MANUAL BACKDATING CHANGES

MODEL 3400A

RMS VOLTMETER

MANUAL CHANGES

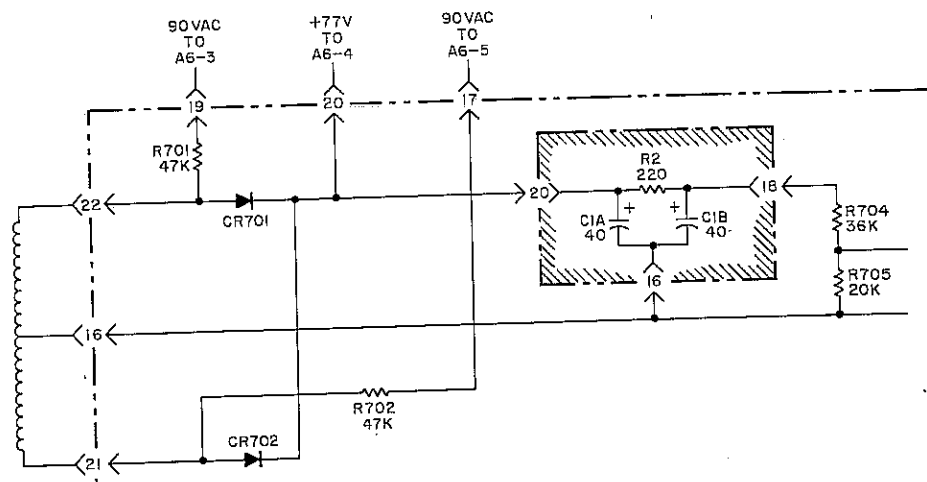
CHANGE #4 Change Figure 6-4, Power Supply Schematic, A7, to the following:

CHANGE #4 (Cont'd) Table 7-1 Replaceable Parts:
 Change R701 and R702 to -hp- Part No. 0693-4731, 47 k Ω . Delete C711 (0160-0167), C712 (0180-0282), R712 (0687-2241), R713 (0686-2225), Q706 (1854-0022), and CR718 (1902-0046).
 Change A7 Board Assembly - Power Supply to -hp- Part No. 03400-66505.
 NOTE: -hp- Part No. 03400-66507 is directly interchangeable with 03400-66505.

Figure C-1. Photochopper A5, Chopper Amplifier A6, and Thermocouple Pair (Part of A4) Schematic and Parts Location Diagram

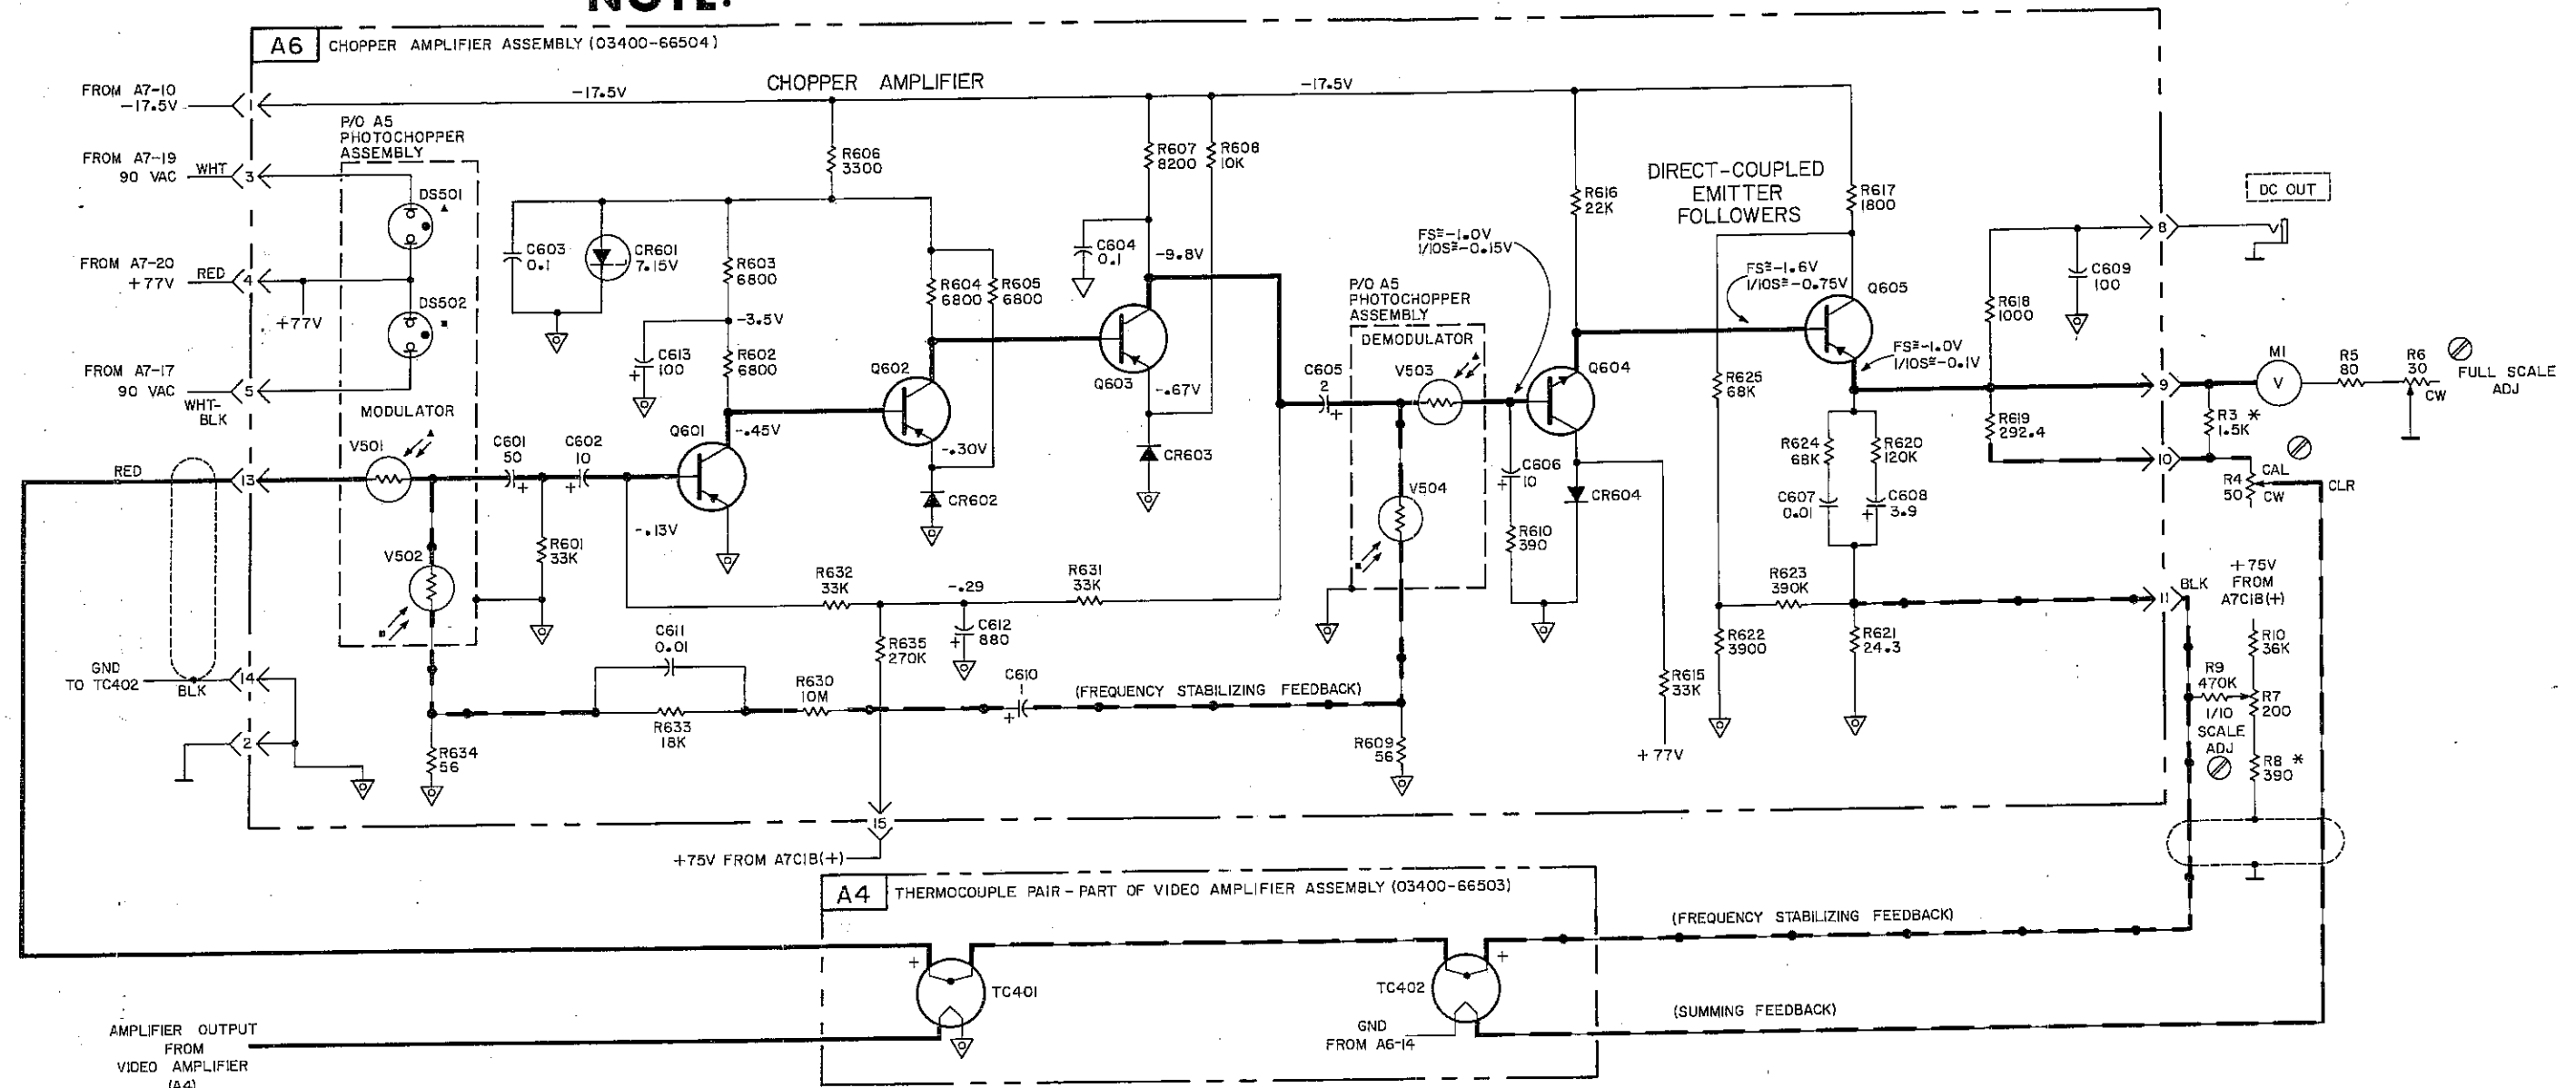
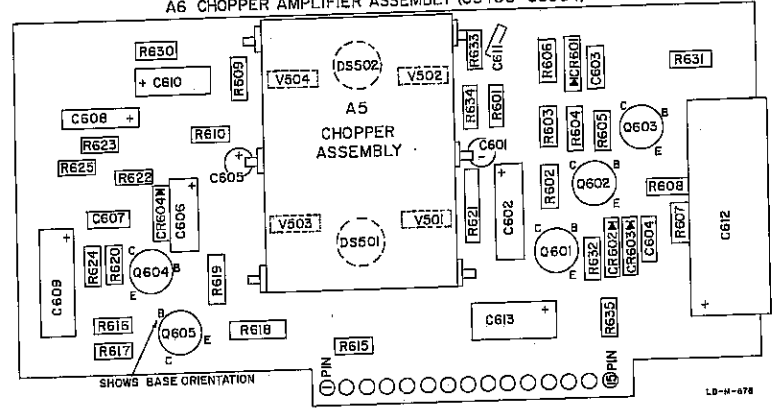
CHANGE #1 Figure 6-3, and Replaceable Parts: Substitute Figure C-1 for Figure 6-3 and replace any component according to Table C-1.

Serials prefixed 322-, 401, 528- and 714- with chopper amplifier board 03400-66504) does not have an emitter follower stage prior to the demodulator. In Section IV delete any reference to emitter follower Q604, and change reference designator Q605 and Q606 to Q604 and Q605 respectively.

CHANGE #5 Figure C-1 and Table C-1:
 Change capacitor C602 to 35 μ F (-hp- Part No. 0180-0064).
 Change resistor R630 to 100 k Ω (-hp- Part No. 0683-1045). Also, change transistors Q601 to -hp- Part No. 1850-0060, Q602 and Q603 to -hp- Part No. 1850-0062.

CHANGE #6 Some instruments (Serial Prefixed 714-) may have a 1 μ F capacitor for C602 (Figure C-1). If C602 fails or if low frequency oscillations ($\pm 5\%$) occur on meter change C602 to 10 μ F described in Table 7-1.

To reduce meter jitter replace all of the above components with components listed in Table 7-1. It is also recommended to change resistor R606 to a 3300 Ω resistor described in Table 7-1.

A7
(hp PART NO. 03400-66507)

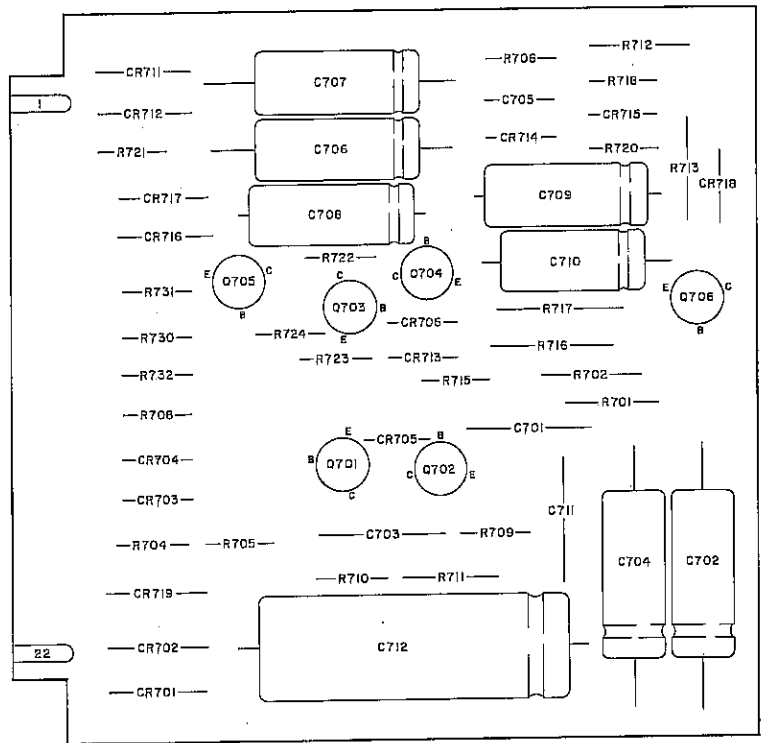
- CHANGE #12 Page 6-7.
Some instruments have a separate green wire from + 77 V to DS502 (on A5).
Page 6-9.
Substitute the below parts locator for A7.
Page 7-3.
Change A7 to -hp- Part No. 03400-66507.

- CHANGE #13 Page 6-9.
Substitute the below parts locator for A7.
